# PRELIMINARY & FINAL DRAINAGE PLAN

## CARRIAGE MEADOWS SOUTH AT LORSON RANCH FILING NO. 2

PUDSP-19-005

**CARRIAGE MEADOWS SOUTH AT LORSON RANCH**  
**FILING NO. 2**  
**STORM DRAIN SCHEMATIC PLAN**

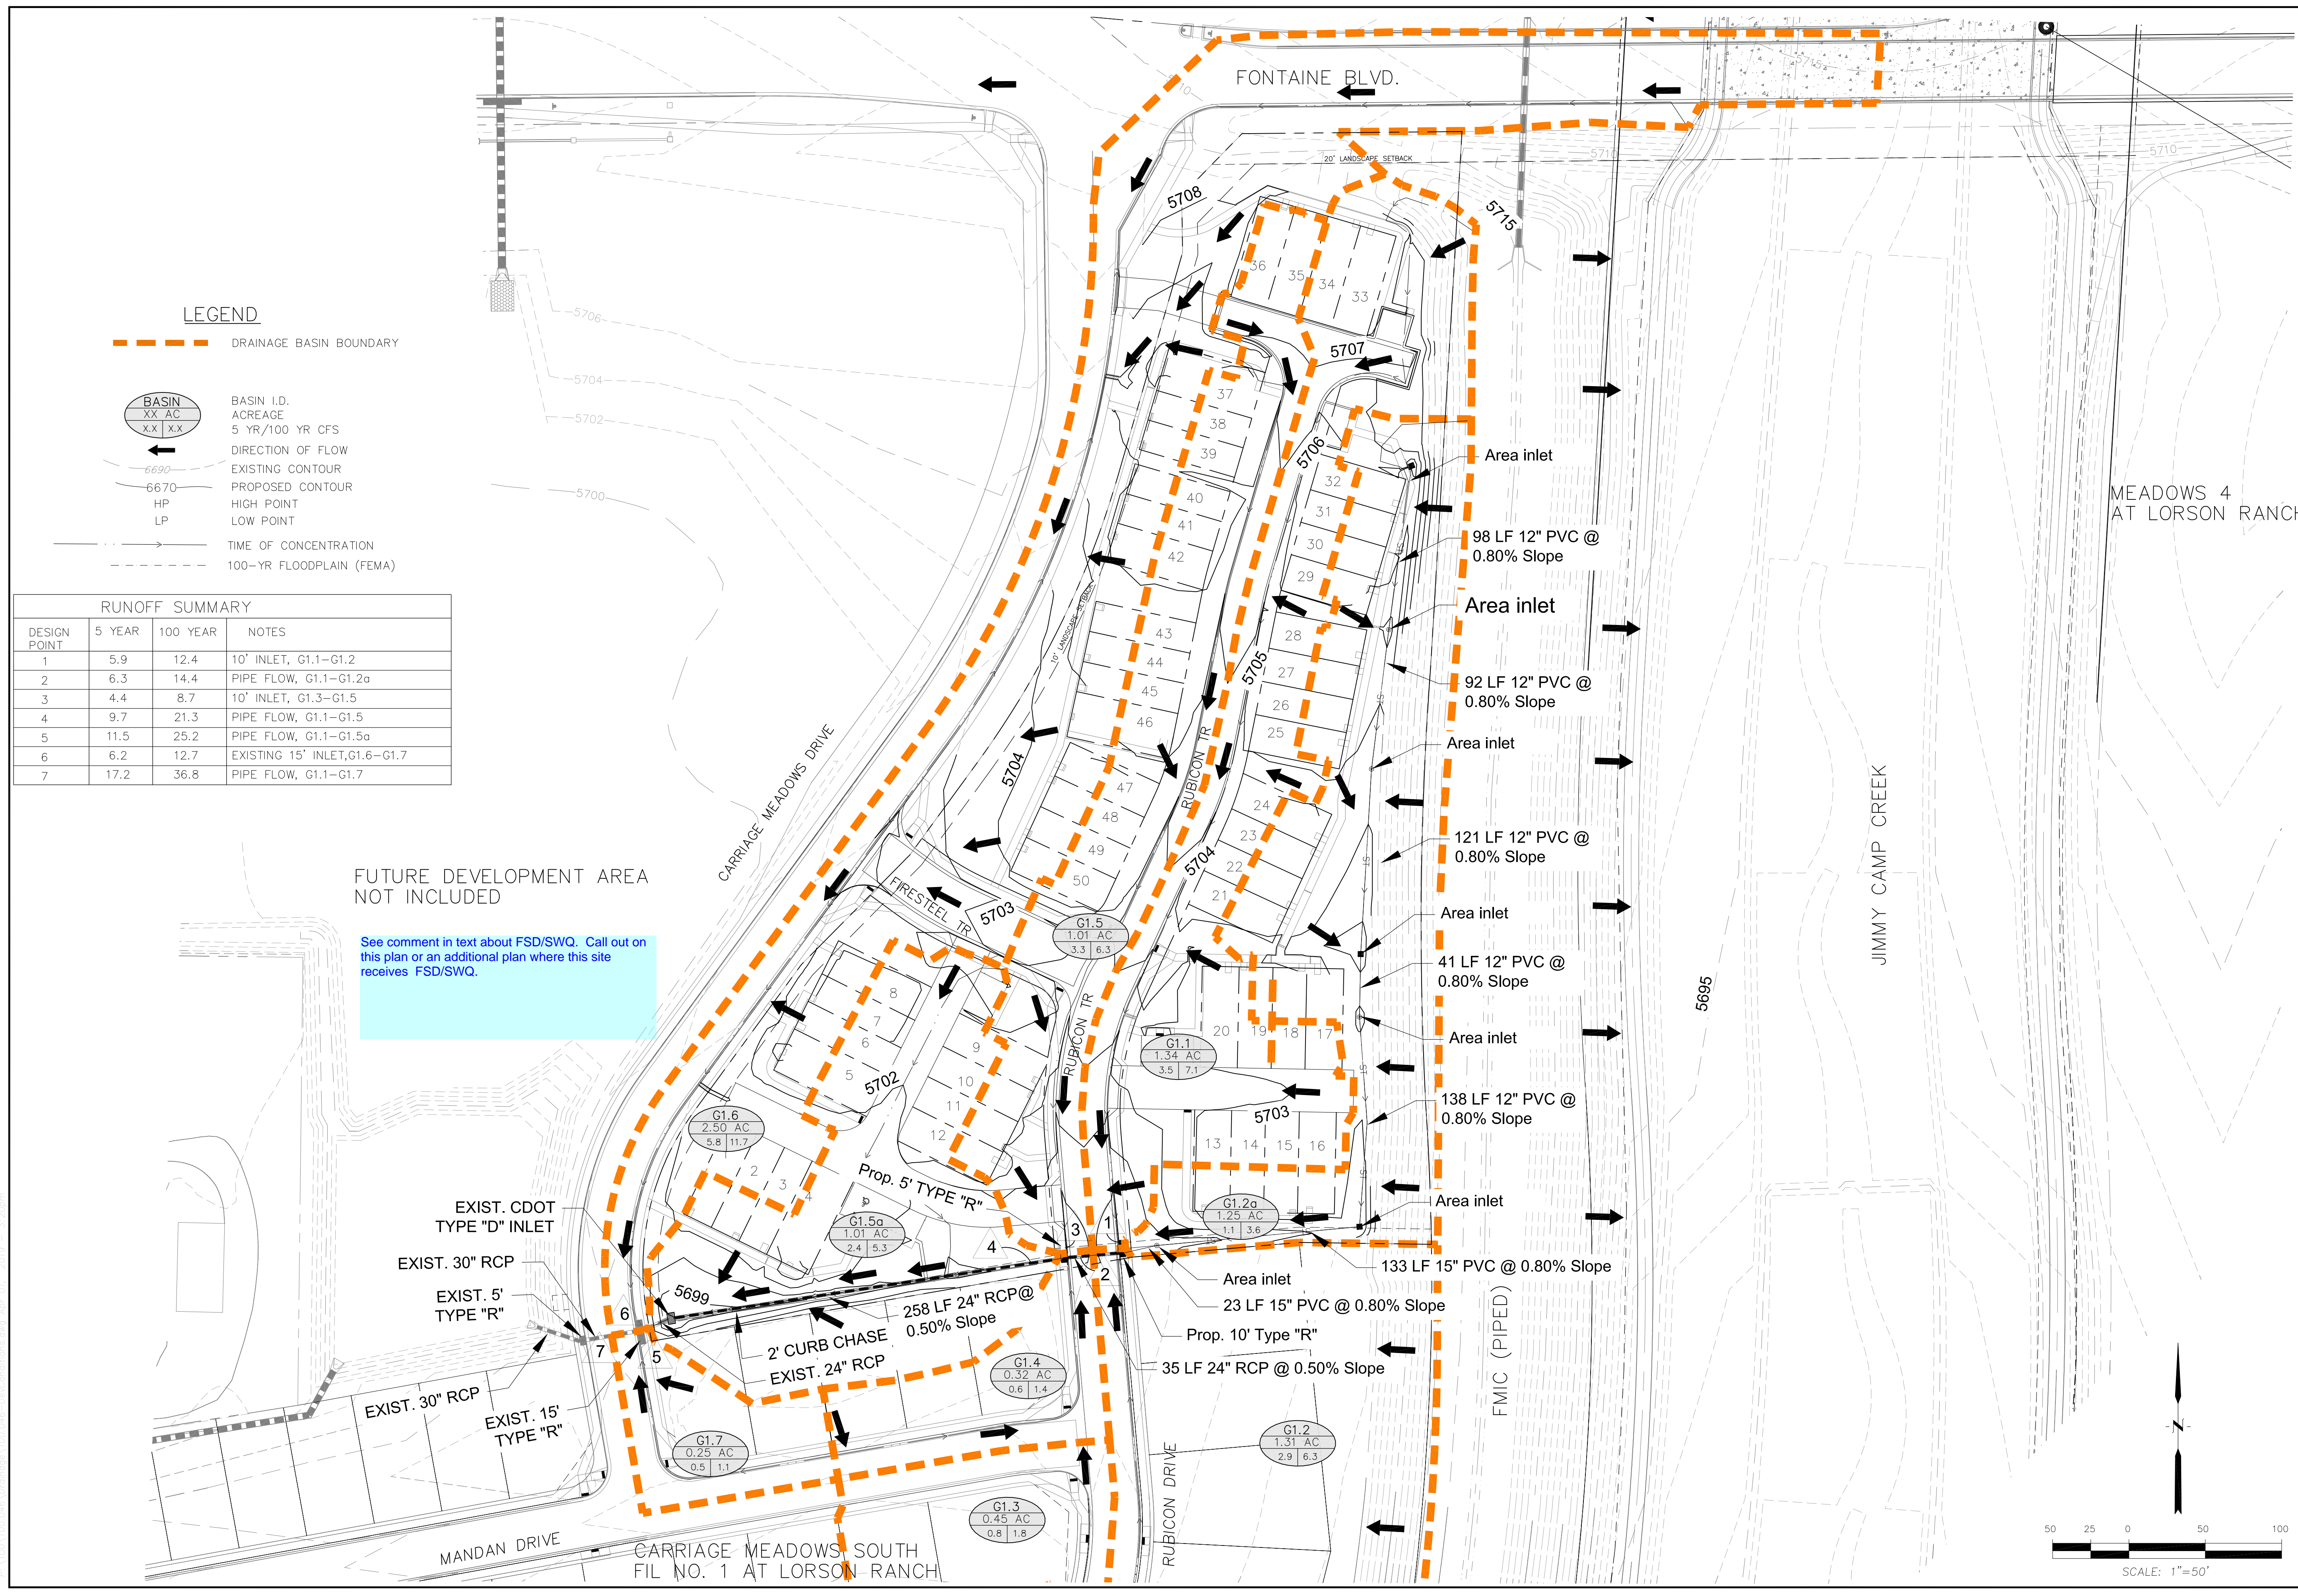
See comment in text about FSD/SWQ. Call out on this plan or an additional plan where this site receives FSD/SWQ.
